Questions and Answers

STRUCTURAL Amendments to Drawings:

END OF ADDENDUM NO. 4

NEW CROATIAN CULTURAL CLUB
615 BARTON STREET
STONEY CREEK ONTARIO

DATE MARCH 2026	DRAWN BY T.M.	DRAWING No. S1.0
PROJECT No. 21279	CHECKED BY R.H. & J.P.C.

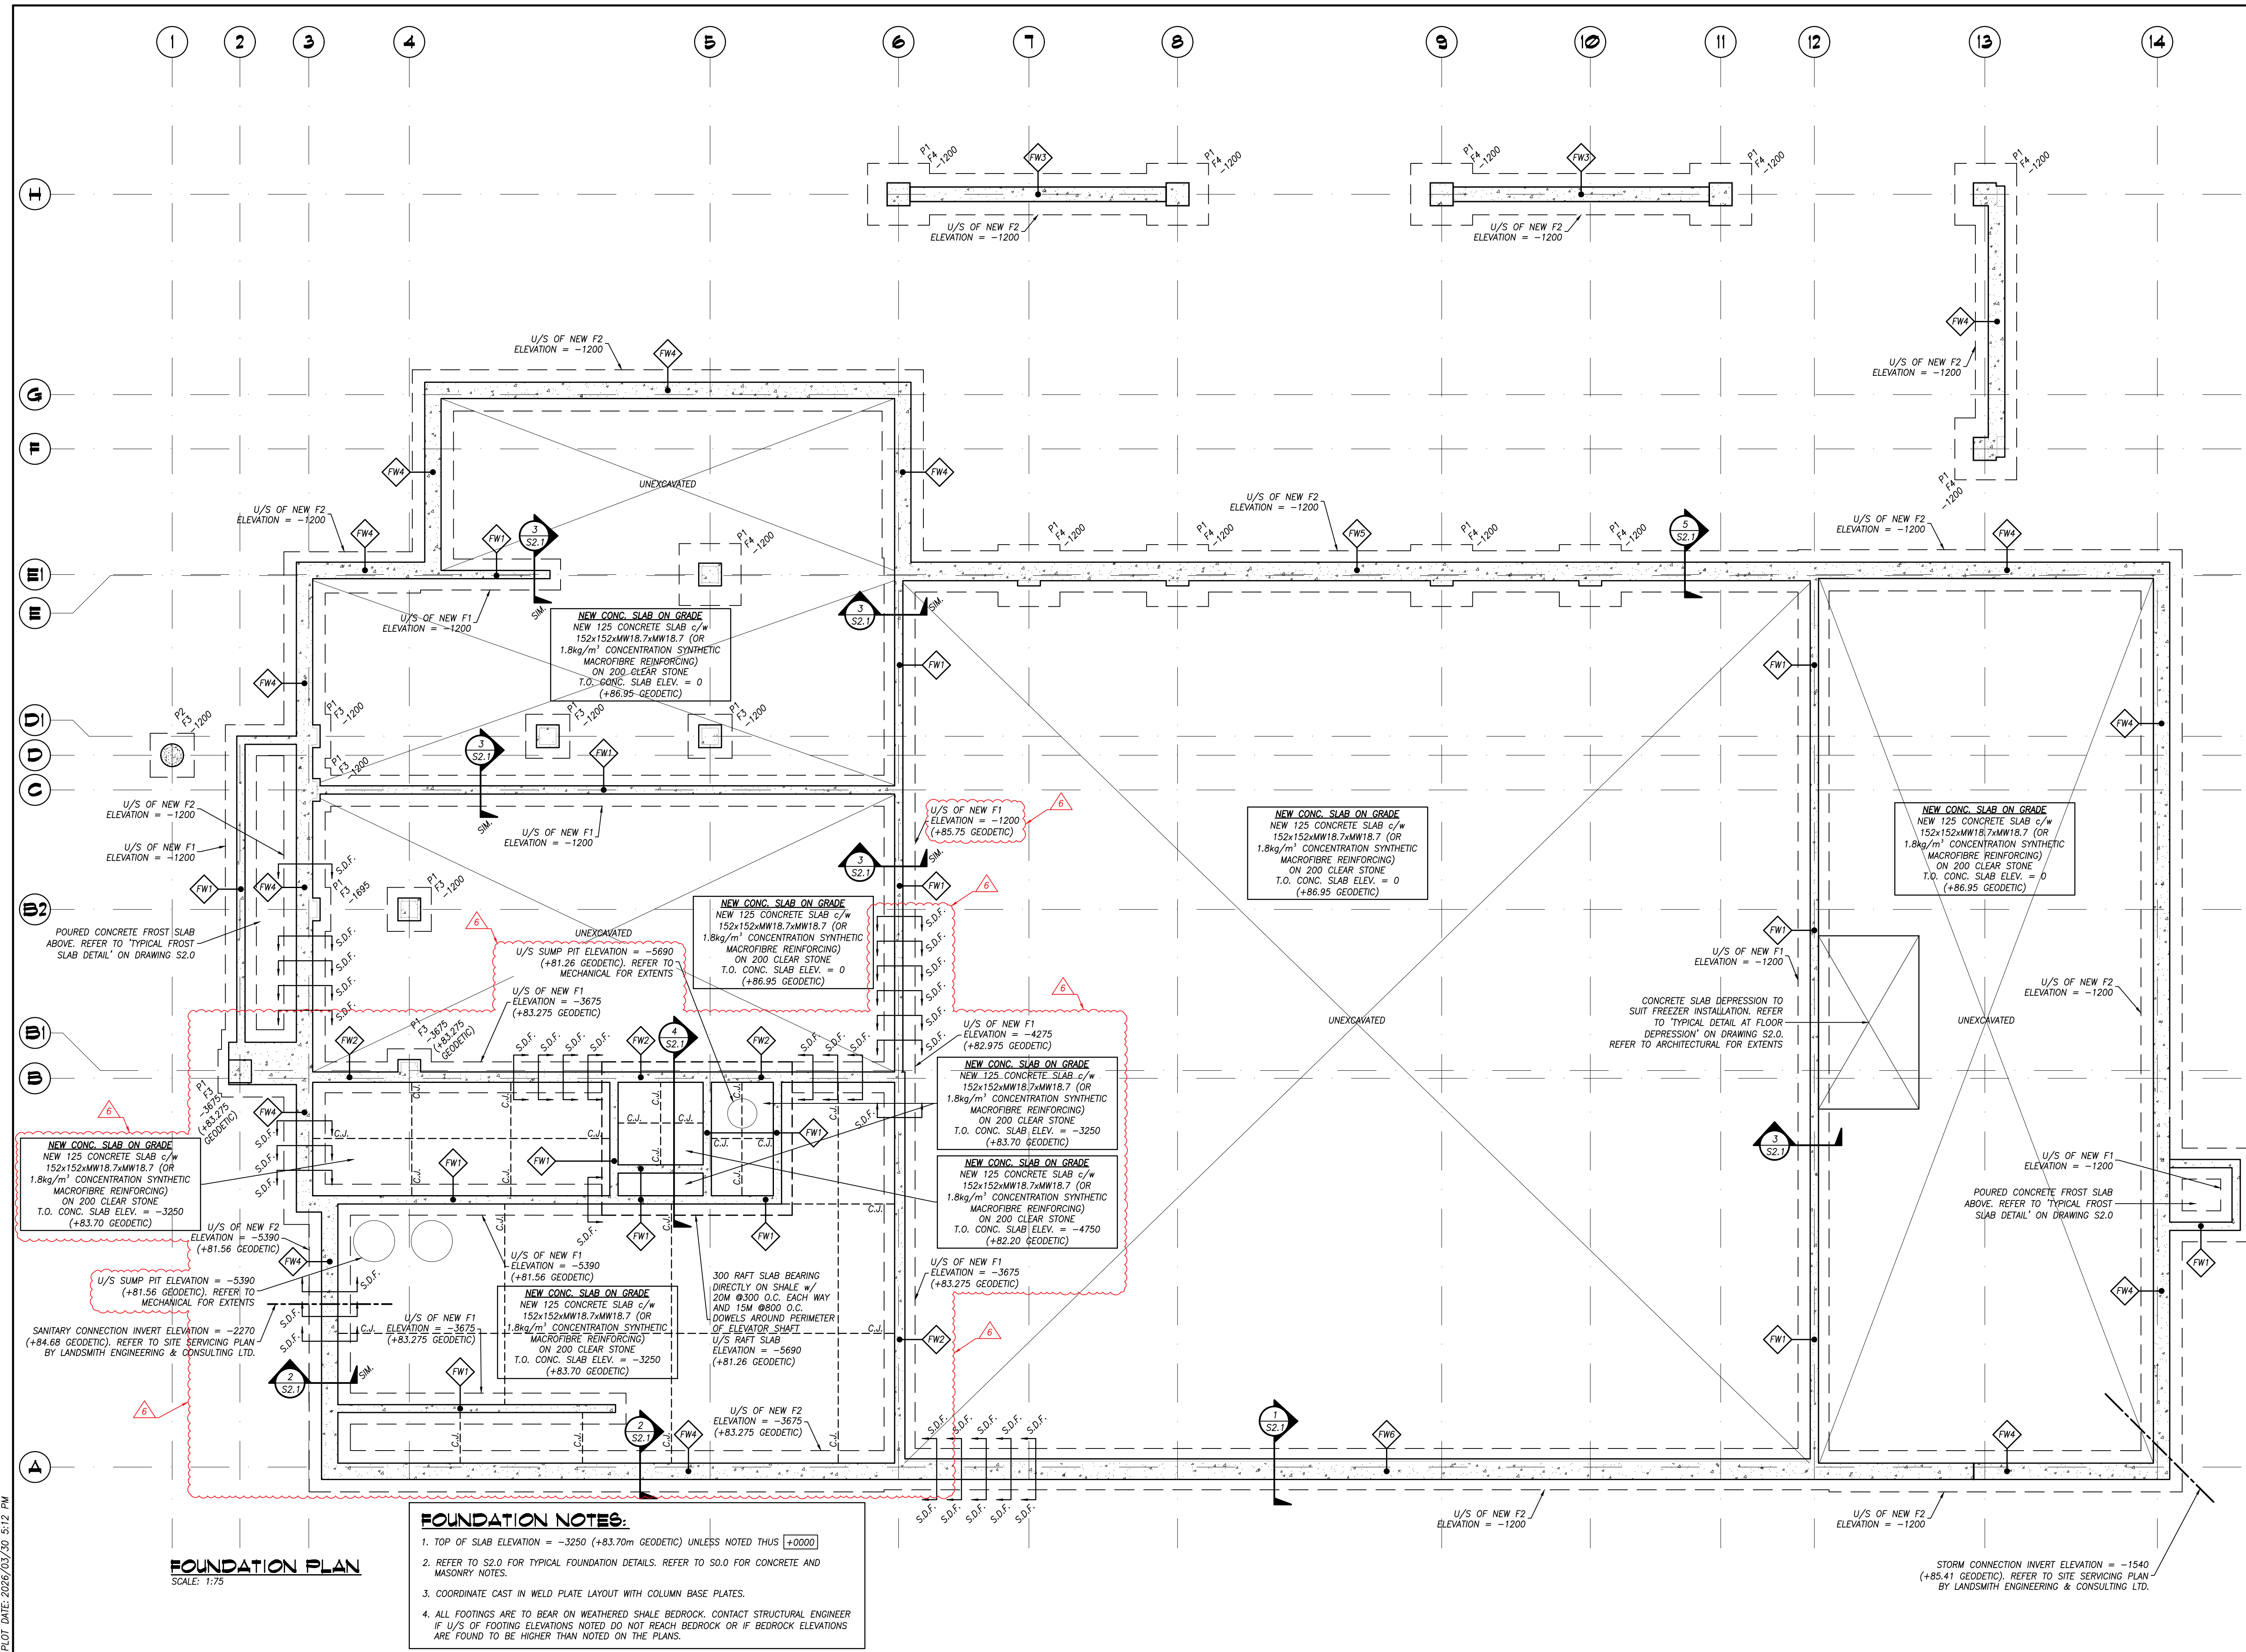
- A. Refer to sheet S1.0:
 - Updated the elevations for the sump pits.
 - Updated the extent of the raft foundation under the elevator shaft.
 - Updated the underside of footing elevations and step-down footings around the sump pits.
- B. Refer to sheet S2.1:
 - Updated section 4/S1.0 to reflect the correct elevations for foundation and slab on grade.
 - Updated the dowels and their splice length on all sections on this sheet.
